MFN 06-204

Subject: **Response to Portion of NRC Request for Additional Information  
Letter No. 6 Related to ESBWR Design Certification Application –  
Tier 1 – RAI Numbers 14.3-1 and 14.3-4**

**Response to Portion of NRC  
Request for Additional Information Letter No. 6  
for the ESBWR Design Certification Application  
Tier 1 – RAI Numbers 14.3-1 and 14.3-4**

Figure 14.3-1-1Tier 1 Design Description and ITAAC Update Process

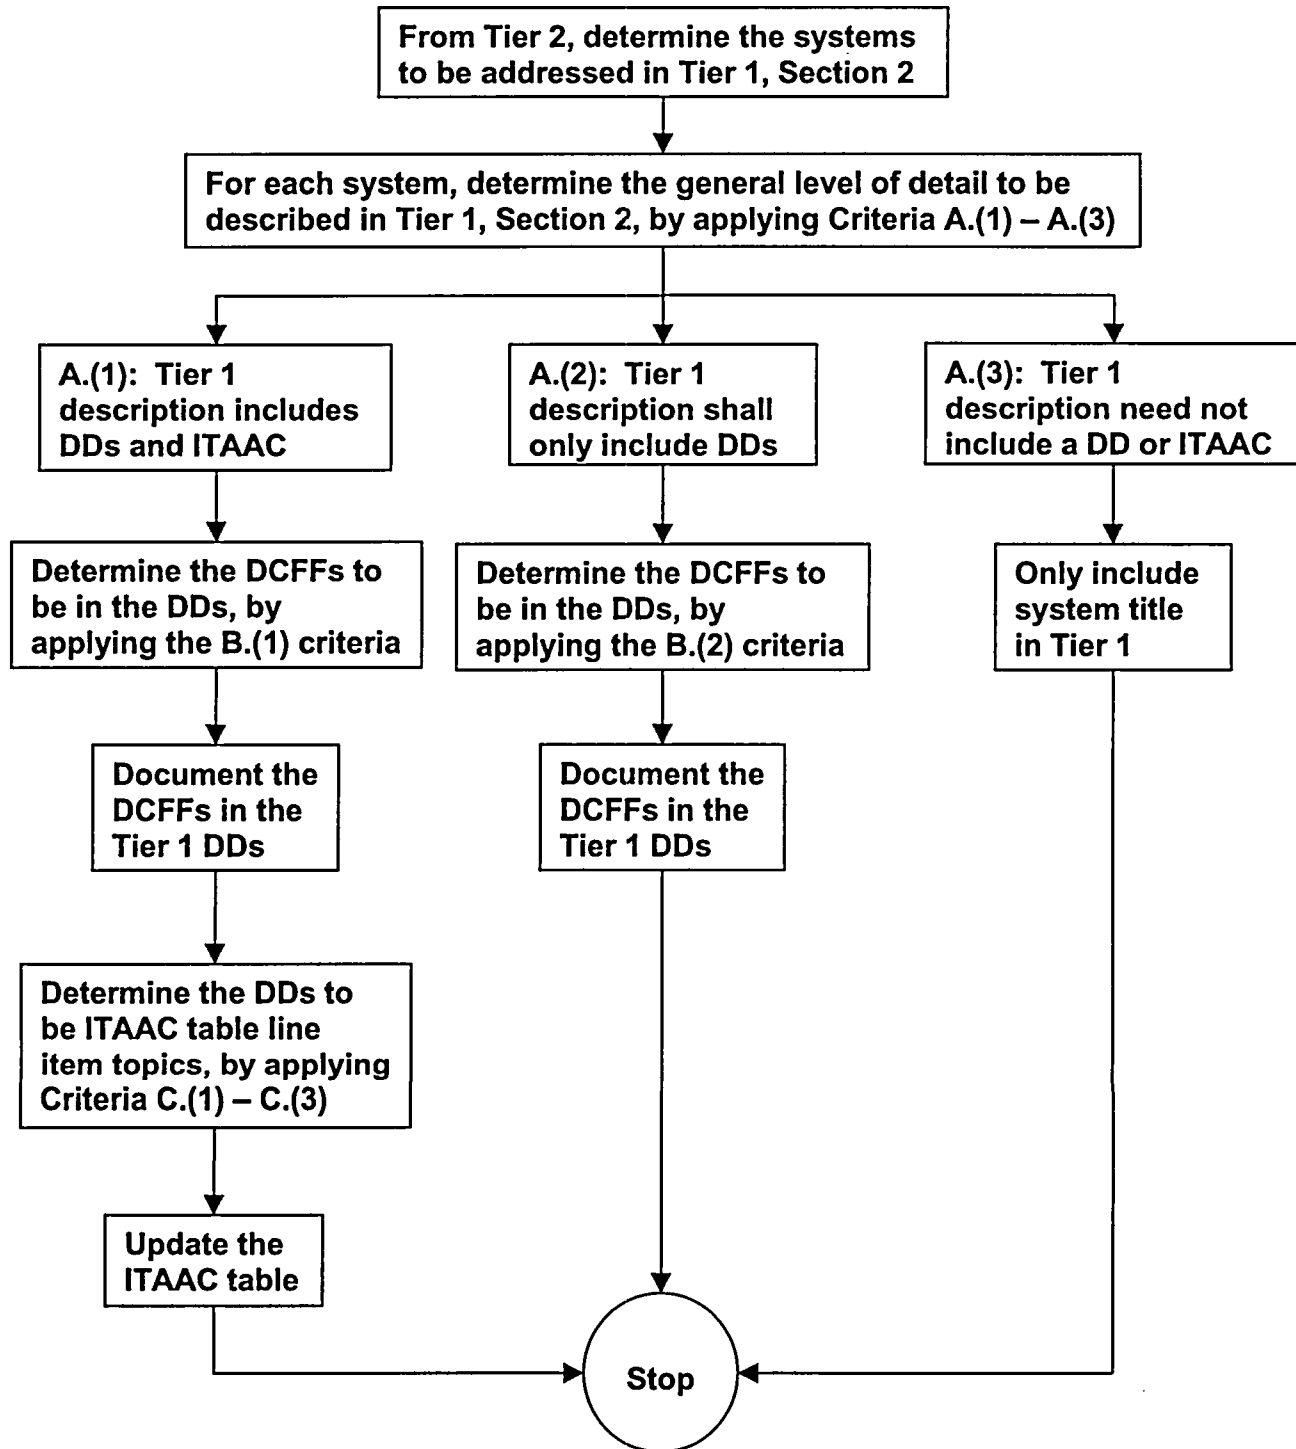
*Provide DCD, Tier 1, ITAAC commitments which include the attributes of the system and its components. This would include not only operational tests, currently listed, of the systems and components but also each of these separate ITAACs and their associated design basis accident conditions:*

- *Seismic capability of all Category I equipment.*
- *Surge withstand capability (SWC) of Class 1E equipment.*
- *Electromagnetic interference (EMI) capability of Class 1E equipment.*
- *Radio frequency interference (RFI) capability of Class 1E equipment.*
- *Electrostatic discharge (ESD) capability of Class 1E equipment.*
- *Environmental capability of Class 1E equipment including room ambient temperature, humidity, pressure and vibration conditions.*
- *Class 1E equipment is powered from its respective Class 1E source.*
- *Separation is provided between Class 1E divisions, between Class 1E divisions & non-Class 1E systems.*
- *The system initiates automatic initiation of ESF and/or RPS as identified when plant process signals reach identified limits.*
- *Data communication between safety and nonsafety systems do not inhibit the performance of the safety function.*

To ensure compliance with 10 CFR 52 in a thorough and consistent manner, GE proposes to re-review and update, as needed, Section 14.3 and the Tier 1 system DDs and ITAAC using the process outlined below and illustrated in Figure 14.3-1-1.

Each system addressed in Tier 2 shall be addressed in Tier 1. The following graded three-level approach is used to determine the general level of detail in each Tier 1 system description. Draft SRPs for 14.3 through 14.3.11 were considered as guidance for establishing details of the system-specific DDs and ITAAC.
